## Exhaust Gas Temperature Sensors, GenSets

SL12-565/EFS/KEL  
August 2012

Owners and operators of MAN Diesel & Turbo four-stroke diesel engines.  
Type: GenSet L21/31 and L27/38 Tier II  
(Engines delivered after 1<sup>st</sup> January 2011)

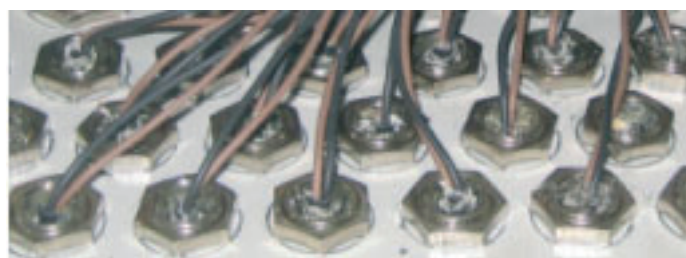
- Dismantle all sensors and junction boxes for both cylinder and turbocharger

- Move the cable tray from exhaust gas pipe level to engine block level
- Install new, long cable sensors including shims/washers

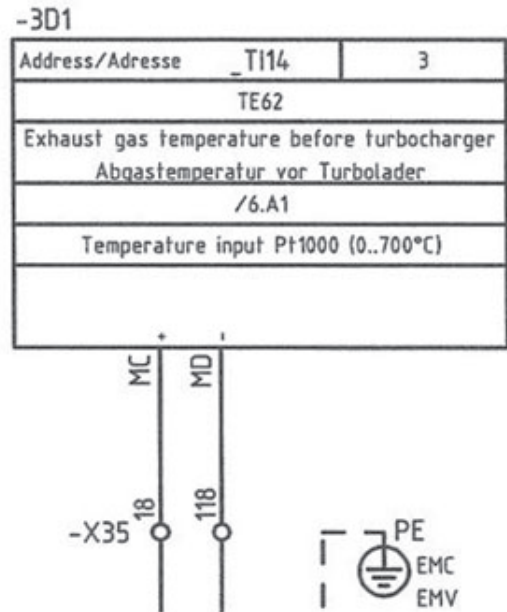
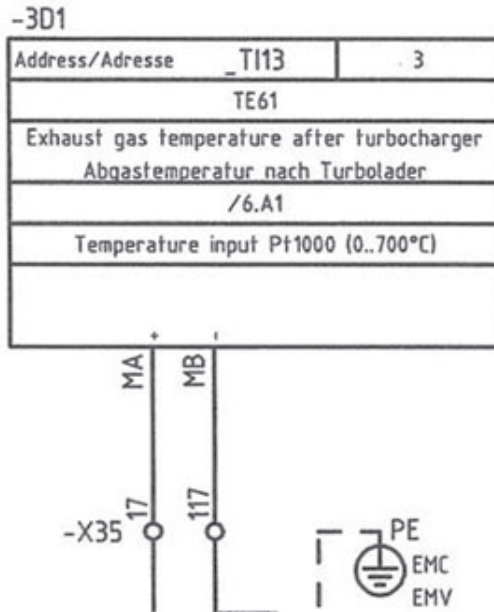
- Place the cables in the cable tray from sensor to SaCoSone cabinet. Make sure that the cables are placed according to above picture to avoid mechanical damage of the cables.
- Shorten the cable in the SaCoSone cabinet so it fits to the terminals

- Make sure that the shield is installed correctly in the cable union to avoid electromagnetic compatibility

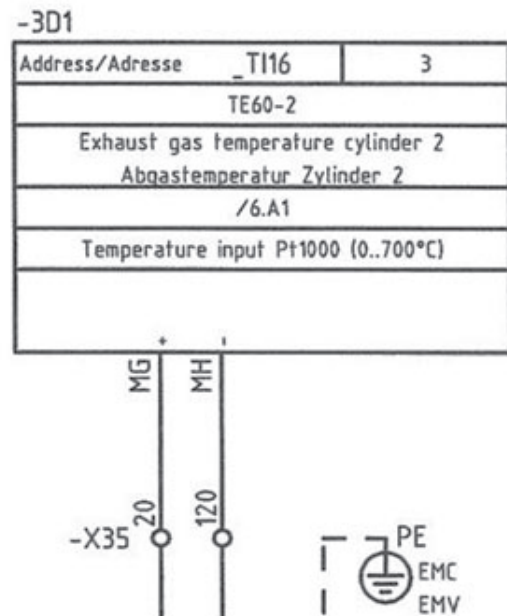
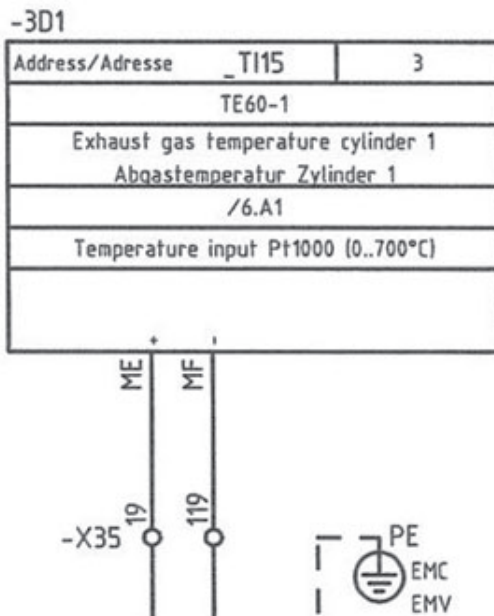
- Connect the turbocharger sensors at the terminals

- Connect the sensors for the cylinder
